Addendum 3 for RFB927940-04

Project Name: WRC Decentralization Phase 4 & Fire Alarm Phase 3 (9279.40 & 9279.41) Bid Issuance #4
DAS RFB #: 927940-04
DAS Project #: 9279.40 & 9279.41
Date: 6/2/2026

FIRST FLOOR FIRE PROTECTION PLAN
 13-FP101

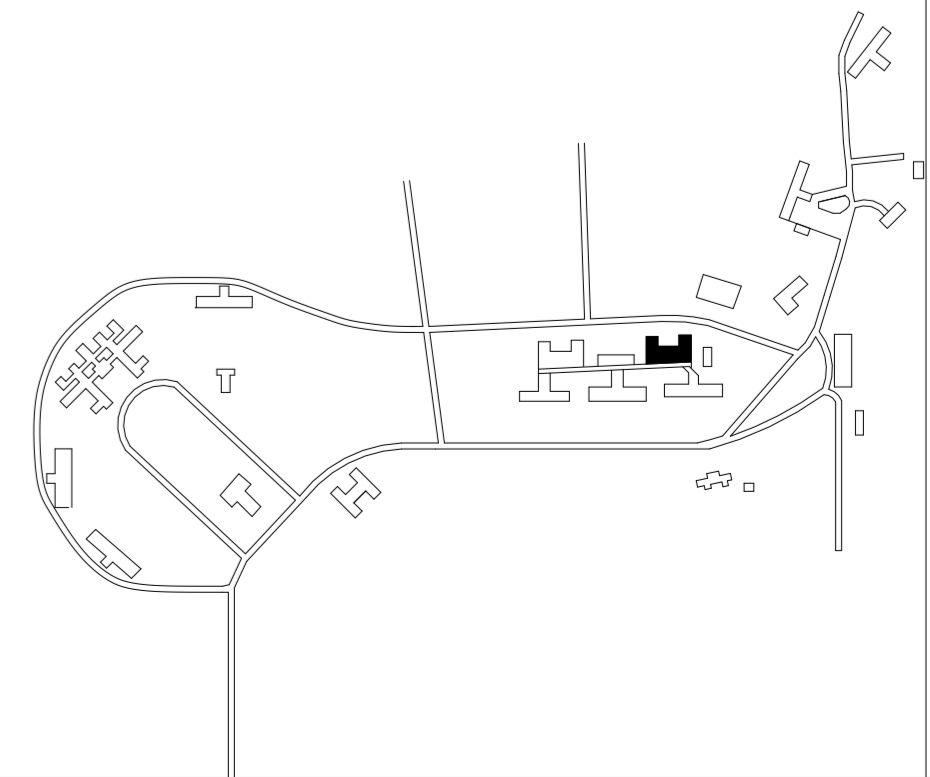
- **13-FP101 – FIRST FLOOR FIRE PROTECTION PLAN:**
 - **ADD** Keynote 13-FP08 to fire protection piping in corridor.
- **13-FP300 – OVERALL FIRE PROTECTION PLAN:**

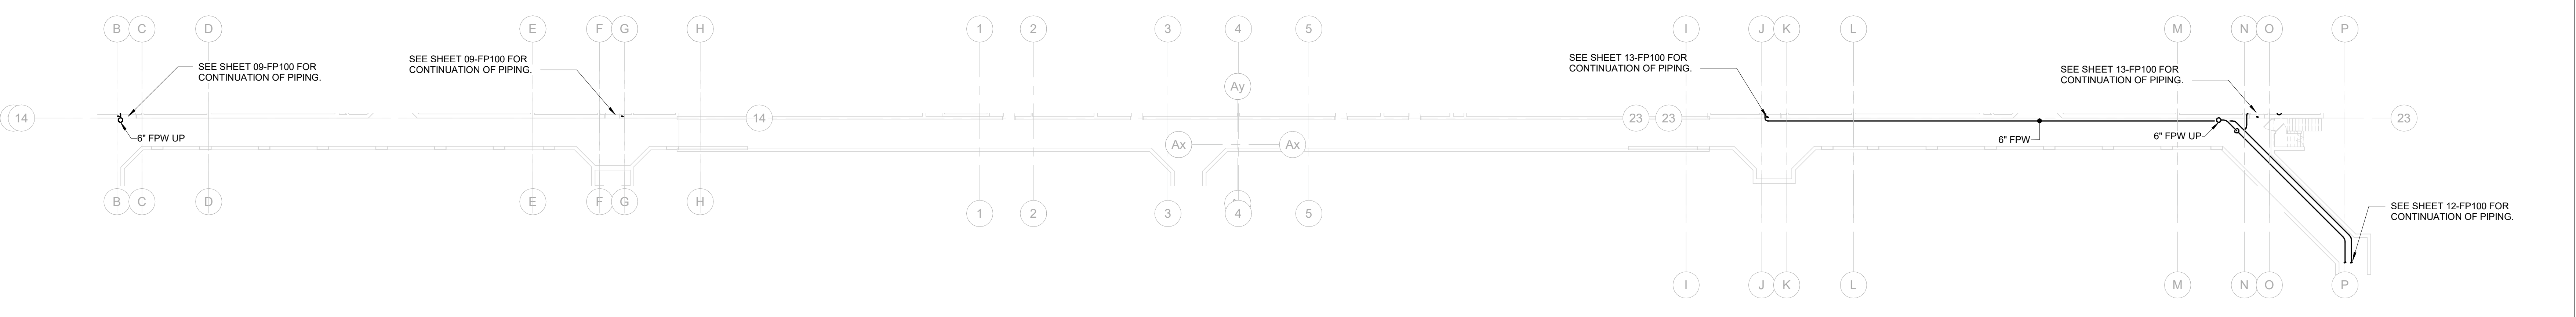
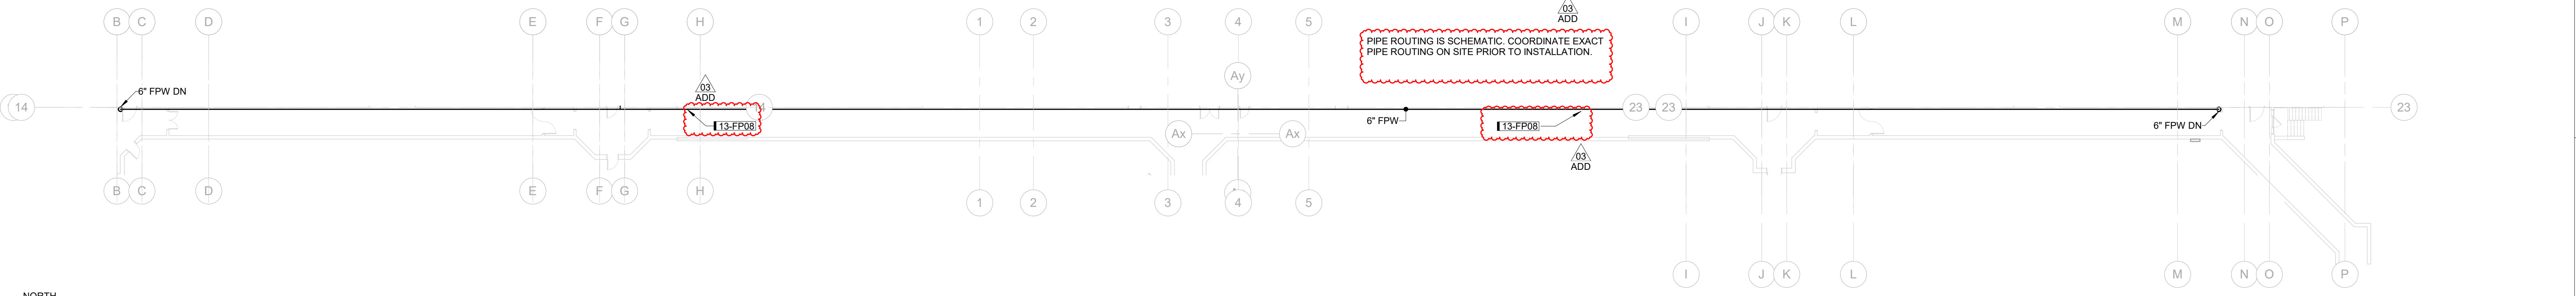
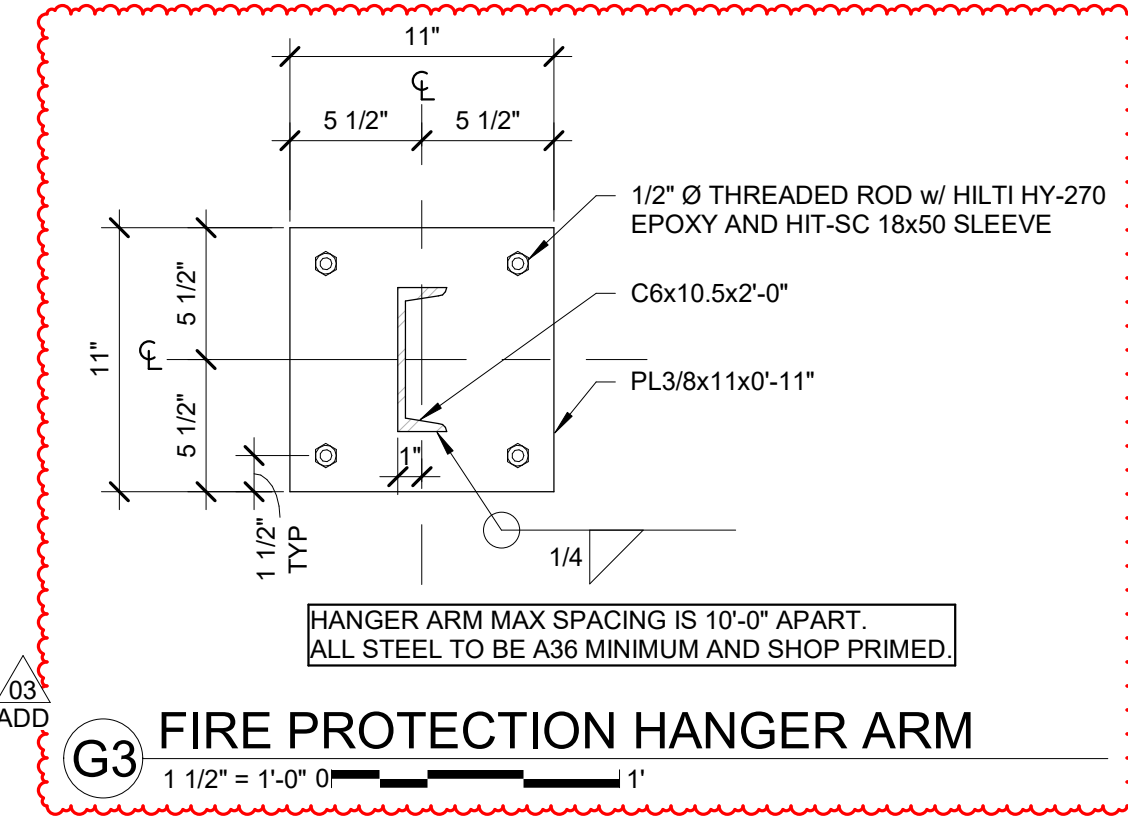
- **ADD** Keynote 13-FP08 to fire protection piping in corridor.
 - **ADD** Keynote Legend
 - **ADD** Detail G3 – FIRE PROTECTION HANGER ARM detail.
 - **REVISE** Note on pipe routing.

KEYNOTES	
KEY	NOTE
13-FP08	ROUTE FIRE PROTECTION PIPING TIGHT TO CEILING. FIELD VERIFY EXACT PIPE ROUTING PRIOR TO INSTALLATION. ATTACH FIRE PROTECTION TO EXISTING WALLS WITH DETAIL G3/13-FP300.

BASEMENT MECHANICAL DUCTWORK PLAN
13-M200

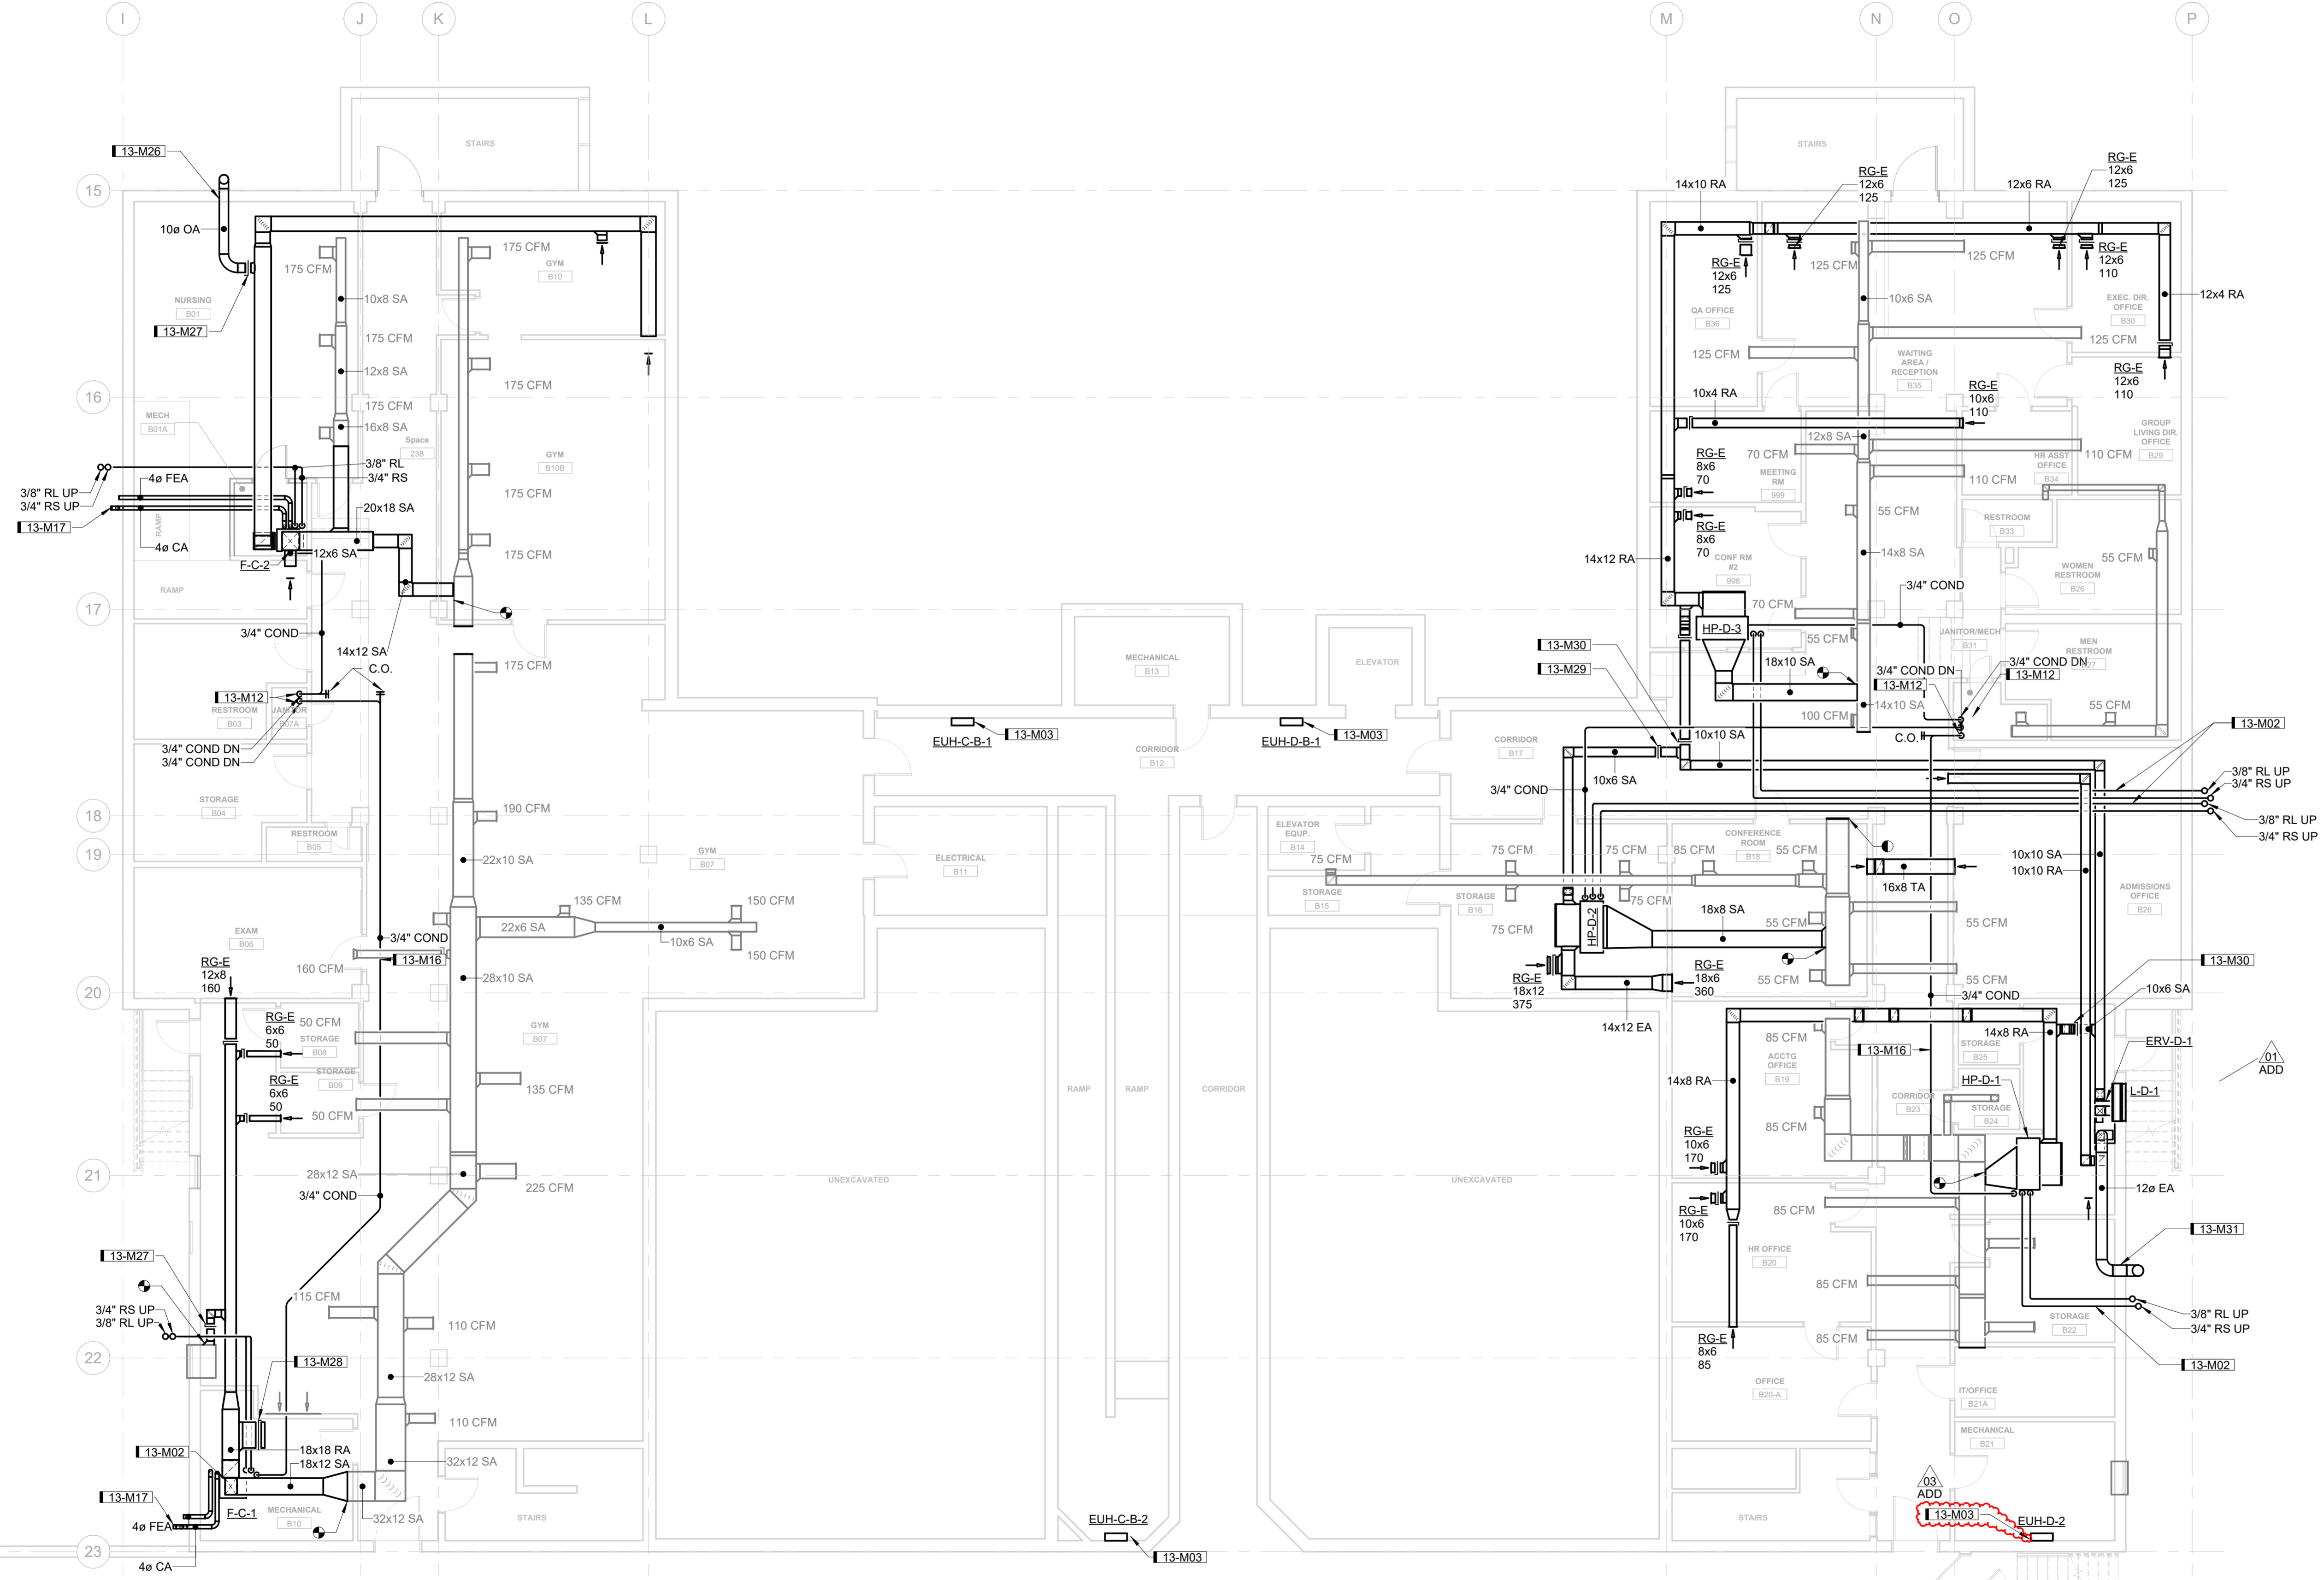
- **13-M200 – BASEMENT MECHANICAL DUCTWORK PLAN:**
 - **ADD** Keynote 13-M03 to EUH-D-2.
- **13-M201 – FIRST FLOOR MECHANICAL DUCTWORK PLAN:**
 - **ADD** Keynote 13-M03 to EUH-CD-5 and EUH-CD-6.
